## Origination Form Proposed Revisions to a Standard Plans Index

Originator:	Turley, Joshua	Index Number:	700-020
Date:	4/3/2024	Sheet Number(s):	2
E-mail:	Joshua.Turley@dot.state.fl.us	Index Title:	MULTI-COLUMN GROUND SIGN

AND	DAJL	CONNECTION		DLIAILS
SIGN		INDEX	SHEET		
				700-020	2 of 3

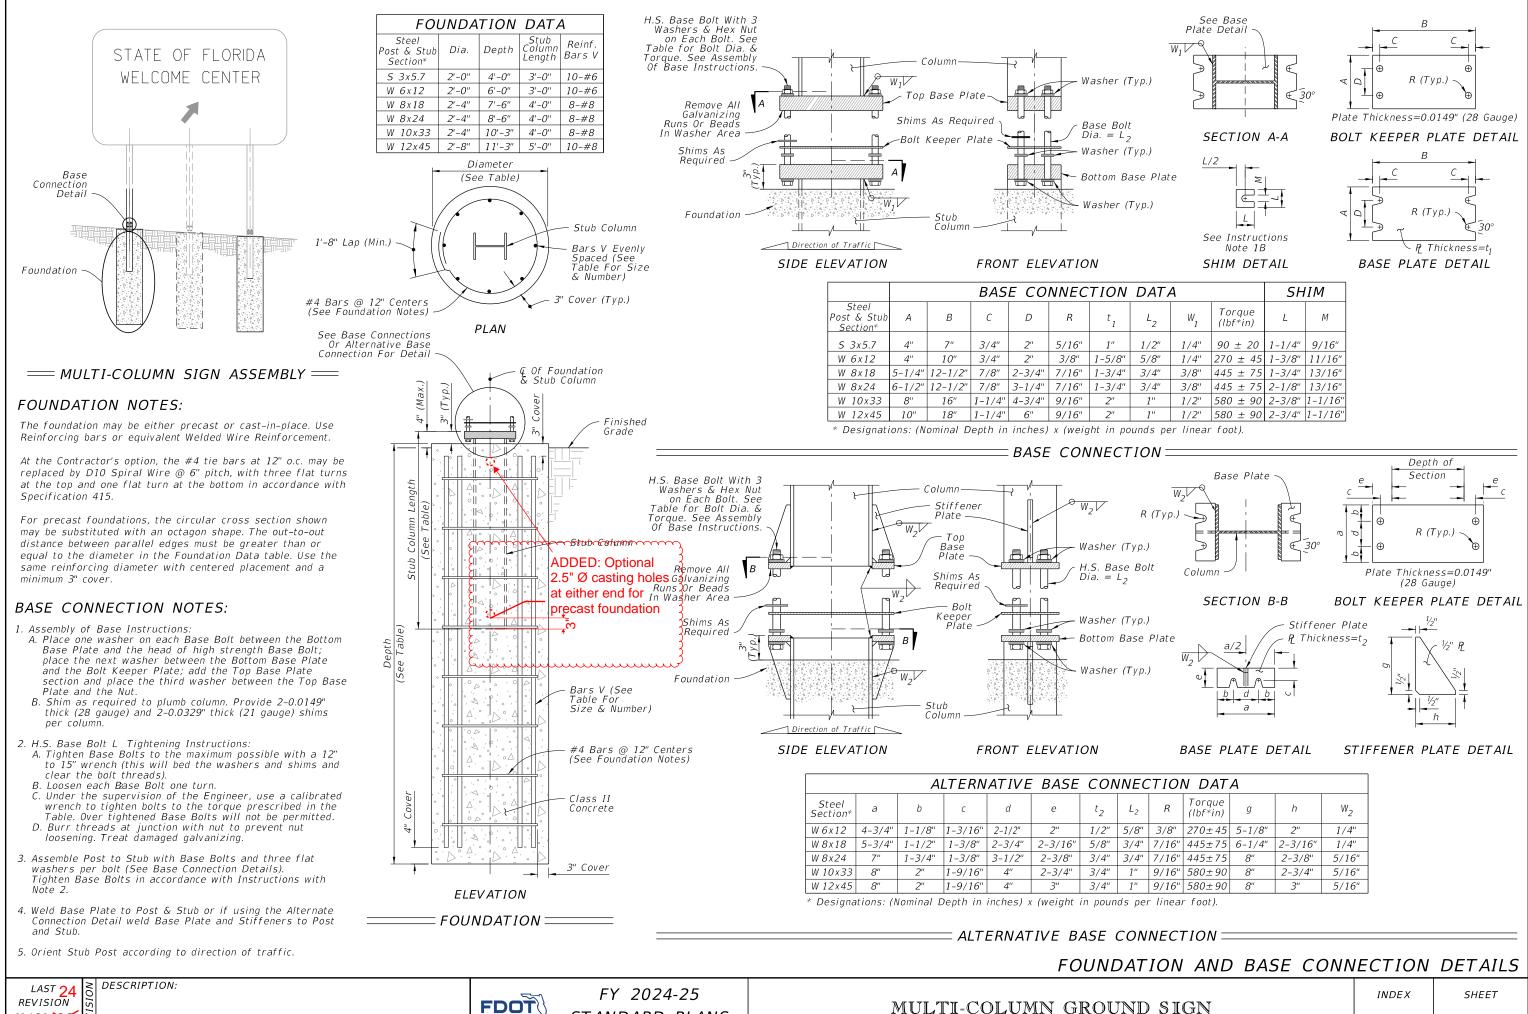
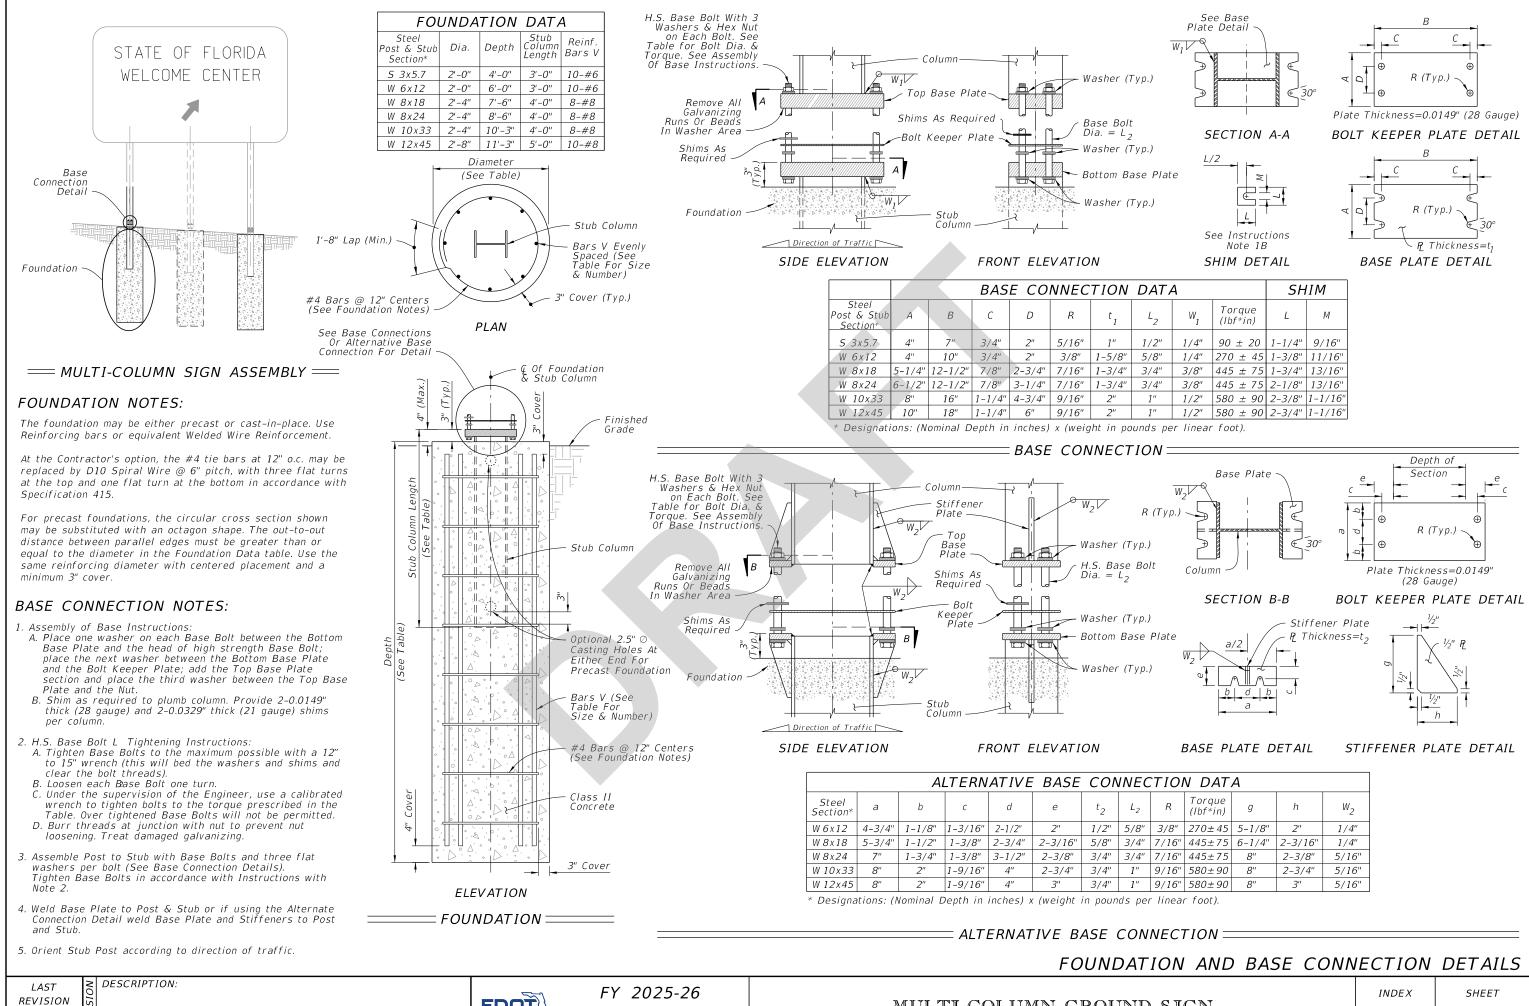
Sheet 2: Adding casting hole option in the stub column to allow for horizontal precast casting. Modifying foundation detail to show the holes.

Precaster requested the casting holes so that they could cast horizontally and not get voids around the embed caused by trapped pockets of air. The holes allow the air bubbles to escape during vibration.
